Re: Amendment to License 12-18215-01 and
Lixiscope Product Certification

We request amendment to our above referenced license and
product certification to add the following:

TOLERANCES (EXCEPT AS NOTED)		LIXI INC.	
DECIMAL ± 0.15		SCALE 2	DRAWN BY SPS
FRACTIONAL ± 1/16		APPROVED BY [Signature]	
ANGULAR ± 1°	DATE 9/3/82	DRAWING NUMBER LS-82-X (PORTABLE)

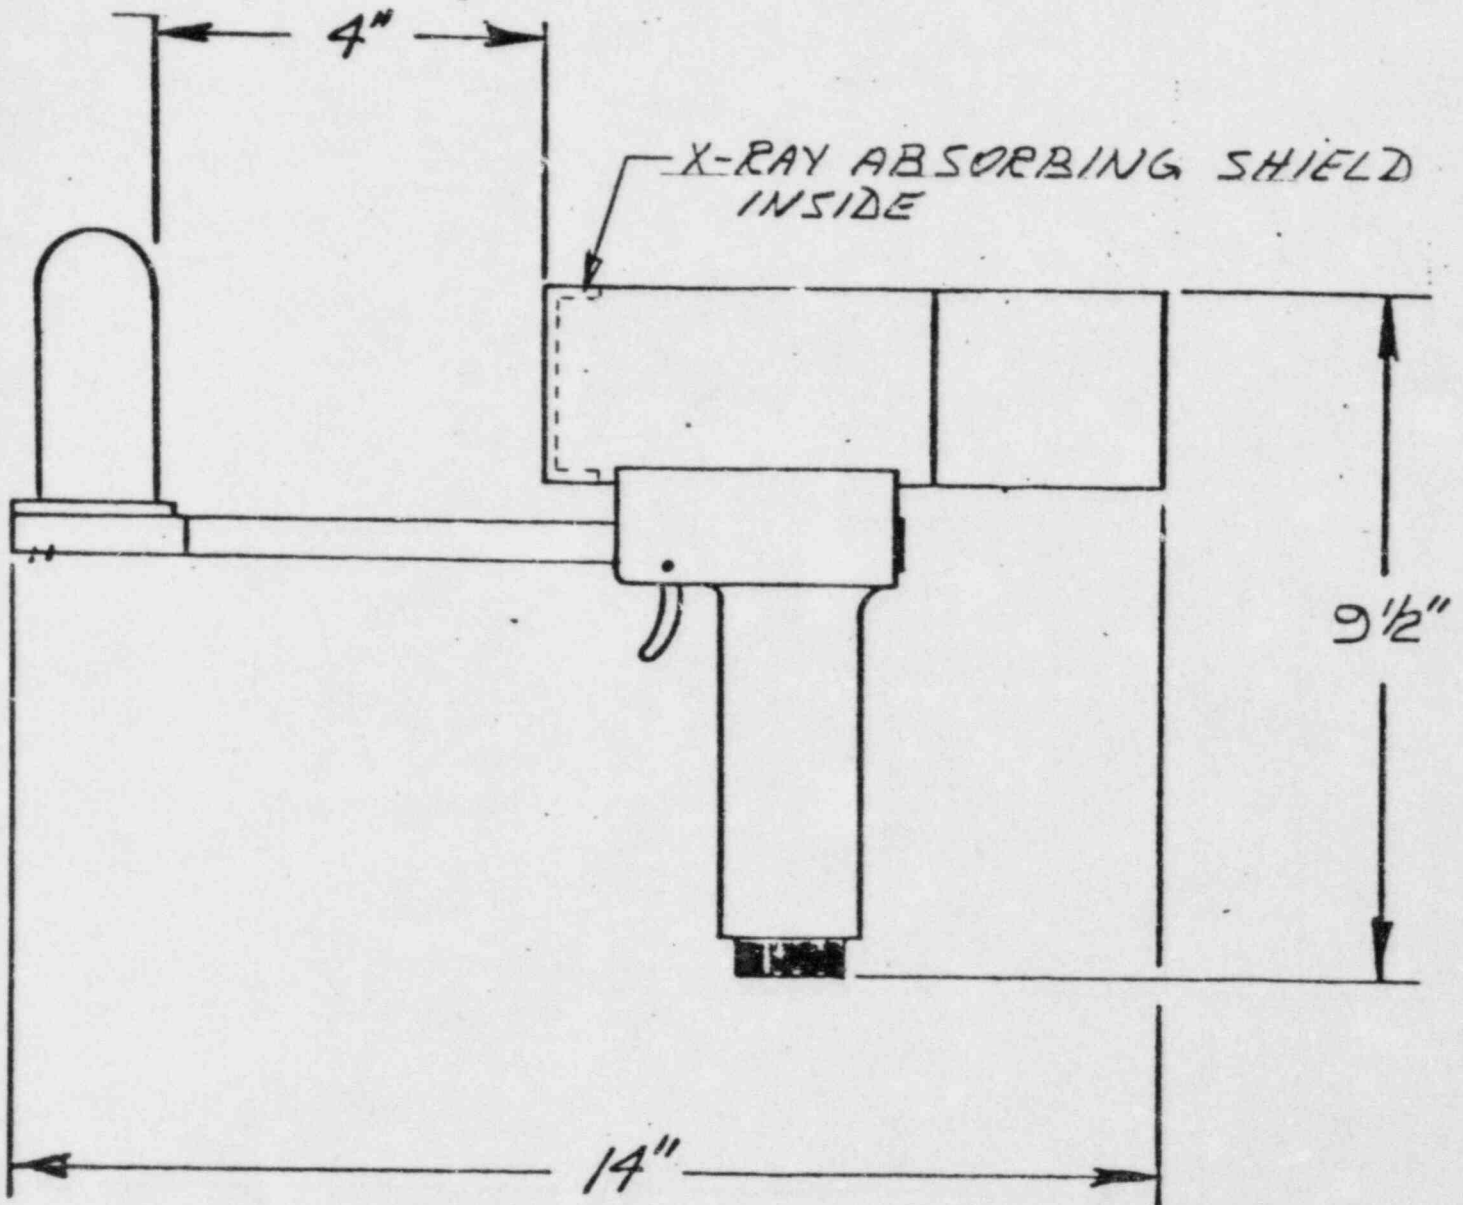
- a) Model LS-80 Series for industrial use, with a stainless steel scope body and source head. This description is already on file with the NRC Product Certification Branch.
- b) Model LS-82 Series for industrial use, with an aluminum body shell casing and stainless steel source head. Drawings are enclosed.
- c) Model LSM-80 Series for medical use. This unit is identical to the LS-80 industrial scope, except for the required different labeling for medical use. These medical labels are on file with Joe Del Medico of the NRC Medical License Branch.
- d) Model LSM-82 Series for medical use. This unit is identical to the LS-82 industrial scope, except for the different labeling for medical use. These medical labels are also on file with Joe Del Medico. The medical labels are the same for both the LSM-80 and LSM-82 models.

The same tests were conducted on the LS-82 and LSM-82 models as were done on the LS-80 and LSM-80 models in our original product certification and application. There was no significant difference in test results. See the attached "Test Data for LS-82 and LSM-82 Series Lixiscopes".

TOLERANCES (EXCEPT AS NOTED)		LIXI INC.	
DECIMAL ± .015		SCALE X	DRAWN BY SPS
FRACTIONAL ± 1/16	TITLE		
ANGULAR ± 1°	DATE 9/8/82	DRAWING NUMBER LSM-82-X (PORTABLE) (MEDICAL)	
		APPROVED BY <i>[Signature]</i>

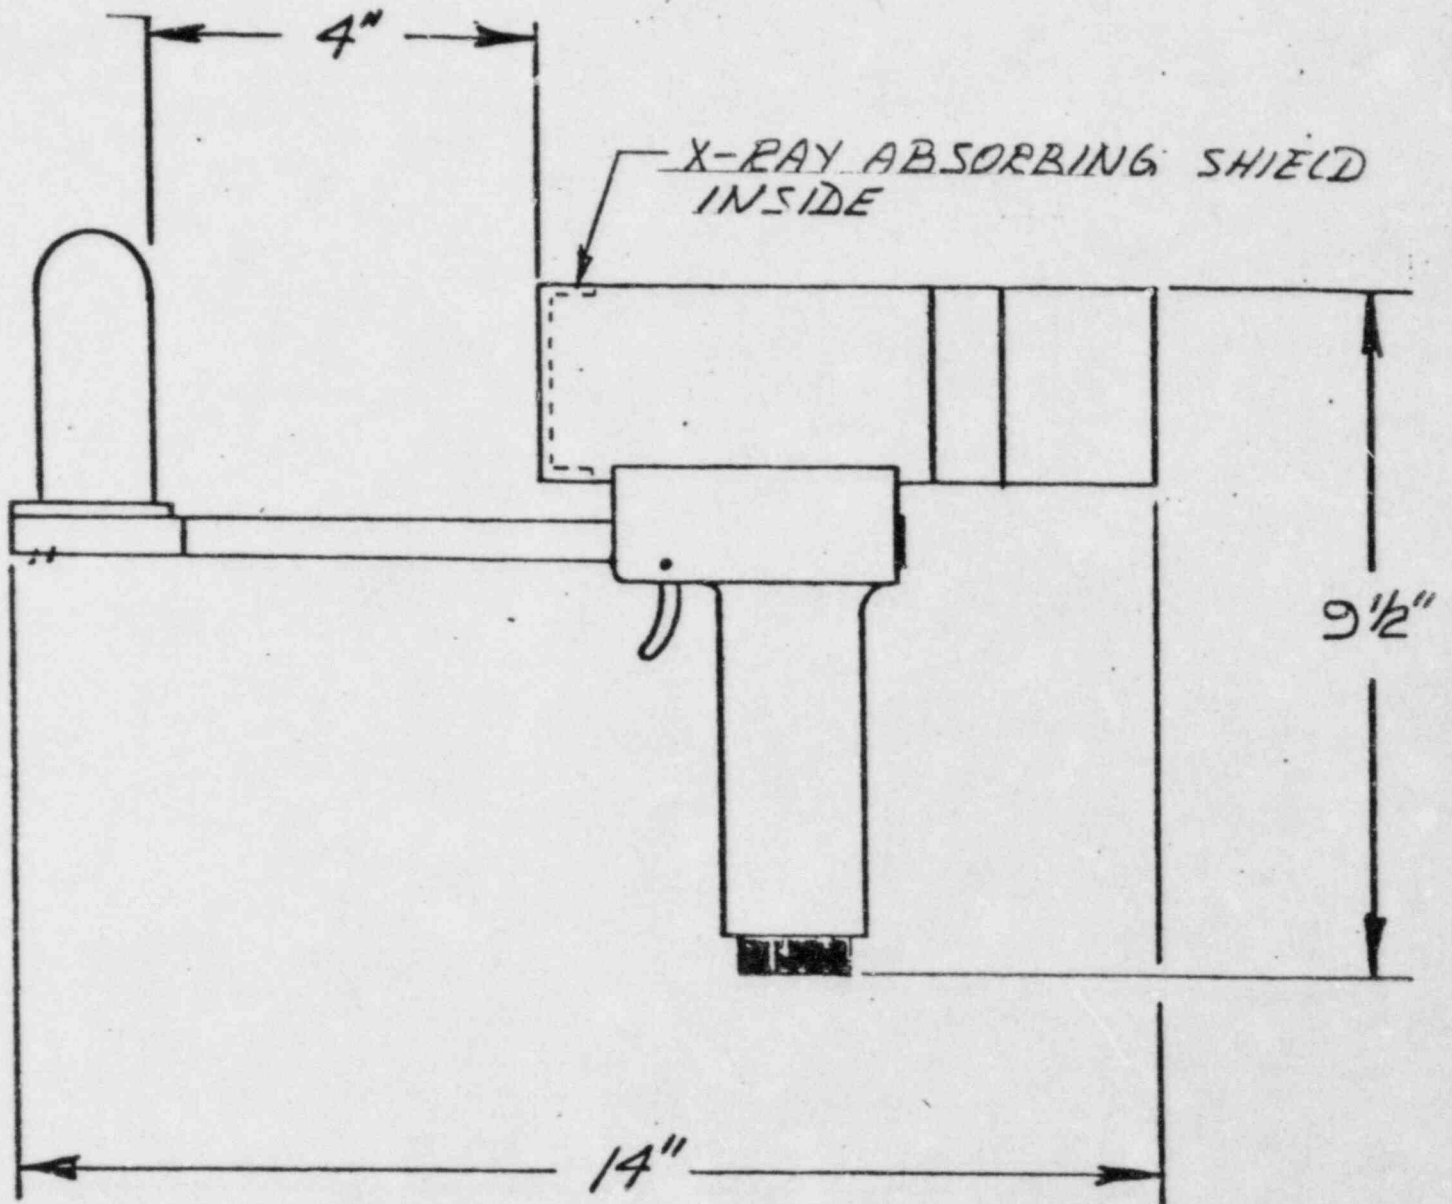
- 4. We have added an electronic audible timer alarm to the LSM-80 and LSM-82 series for medical use, at the request of the FDA. This alarm system is activated and shut off by the Lixiscope trigger. The alarm is sounded ten seconds after the trigger is pulled and every ten seconds thereafter, as long as the trigger is in the "on" position. Please reference the new Lixiscope Instruction Manual (enclosed) which includes instructions for medical users. The alarm is discussed in item nine of this new manual. A schematic of the alarm system is enclosed for your file and the NRC Product Certification Branch records.

HORIZONTAL SHOCK TEST

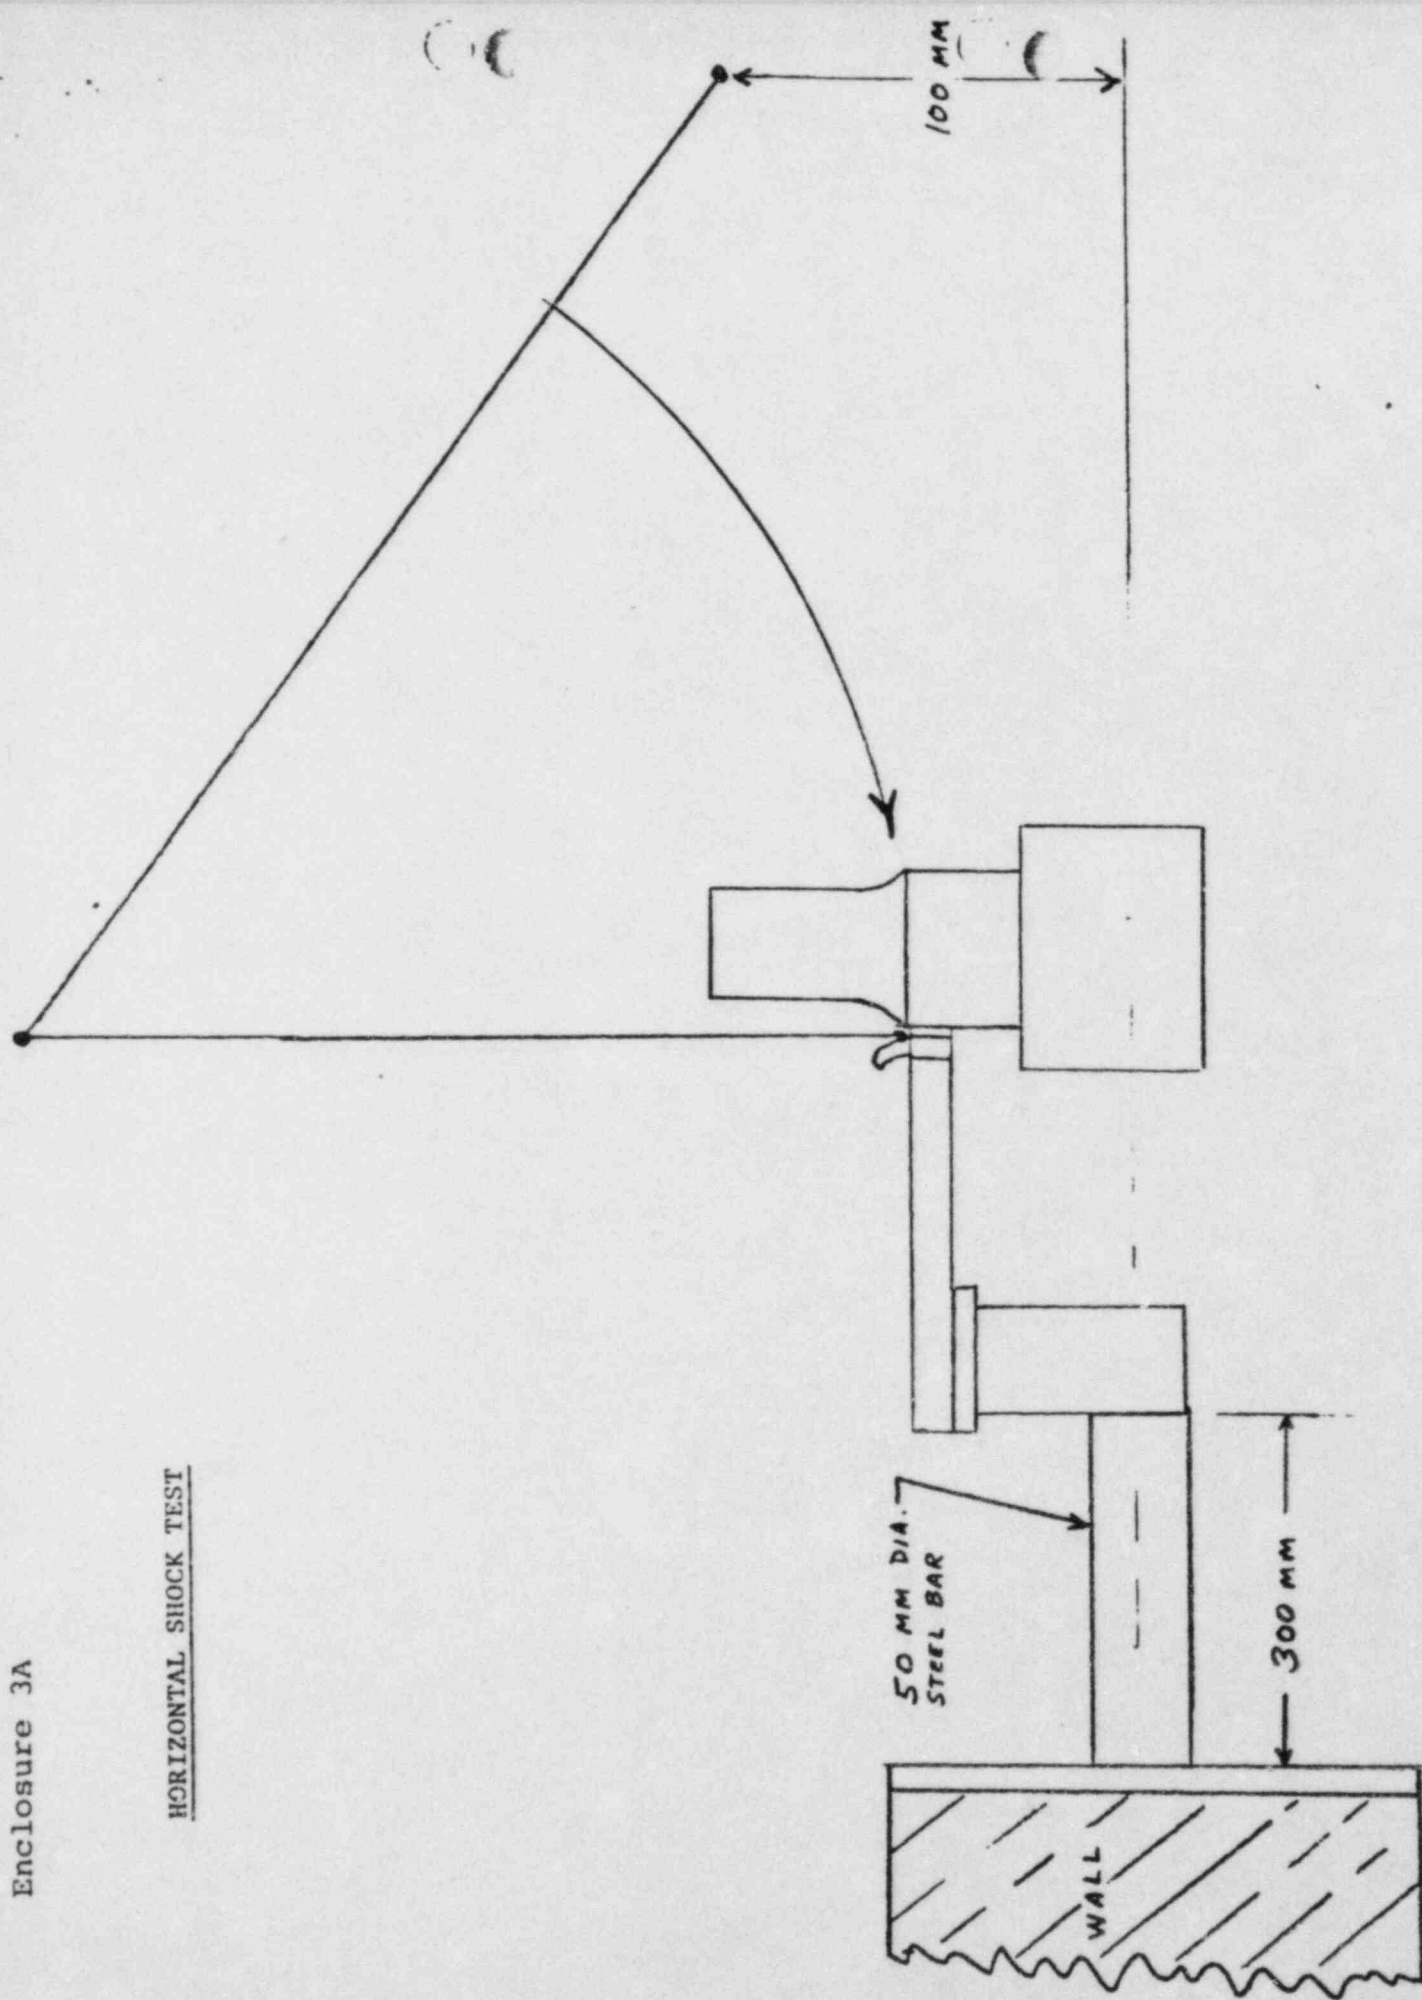
- A) Horizontal Shock Test: After 20 shocks no apparent physical damage was sustained except for some scuff marks on the housing. There were no dimensional changes to the Lixiscope or damage to the isotope capsule itself. The hydraulic exposure system functioned normally. There was no changes in the radiation level at the surface of the holder head (see attached sketch for design of test).

- B) Vertical Shock Test: The Lixiscope was dropped 100 times. After the test the device was visually and mechanically inspected. There were no dimensional changes. The hydraulic exposure system functioned normally and the radiation level at surface remained $< 0.07\text{mr/hr}$ (see attached sketch for diagram of test).

ACCIDENTAL DROP TEST

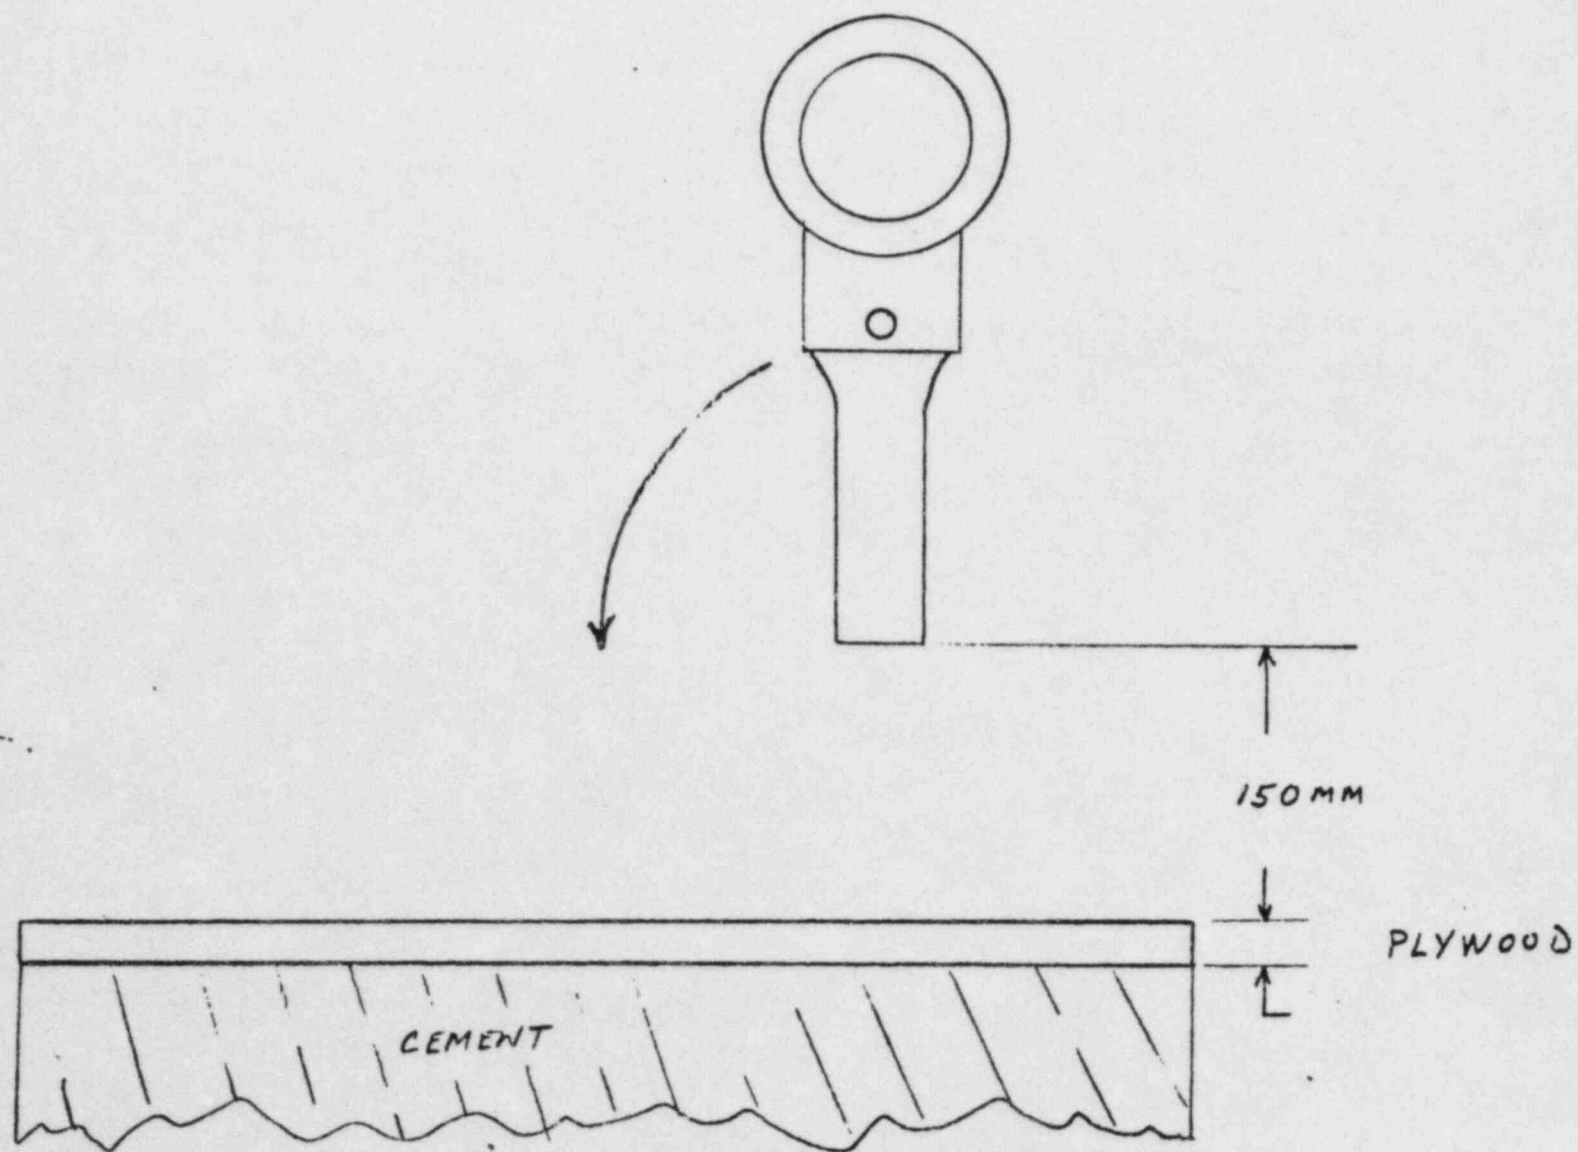
- C) Accidental Drop Test: For drop 1, after five consecutive drops from 5.5 meters slight abrasion marks were found on the surface. The spring system for holding the capsule in the shielded position remained functional. This test was performed on the new Tungsten/Stainless Steel source holder head with all accessories removed as specified. The external radiation exposure rate was $< 0.05\text{mr/hr}$ at one meter from the external surface of the exposure device after the test.
For drop 2, the source holder head (exposure device) was allowed to free-fall one meter onto the target as specified. There was no damage to the device and the radiation level at surface was $< 0.07\text{mr/hr}$.

ENDURANCE TEST

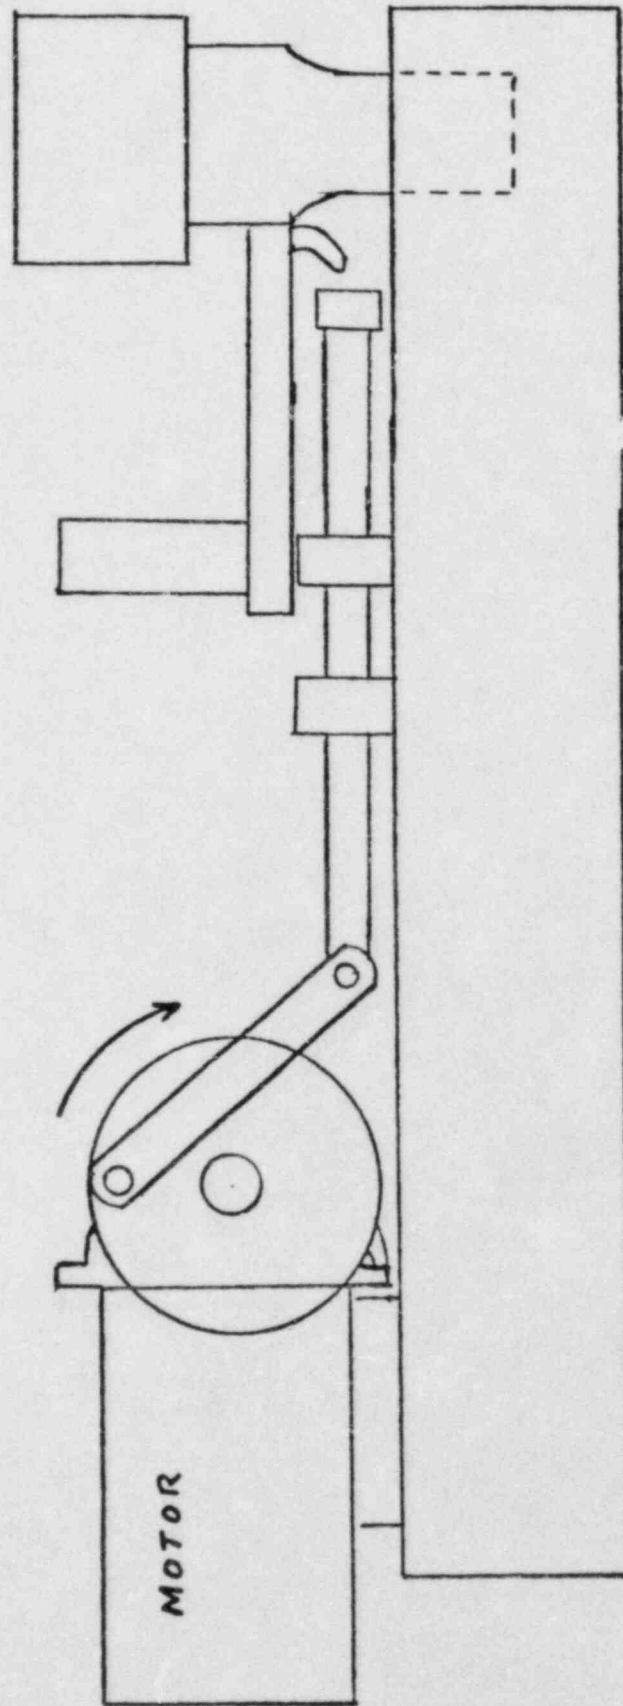
D) Endurance Test: This test setup cycled the trigger from one extreme position to the other is one second. After 100,000 cycles the unit still performed within specifications.
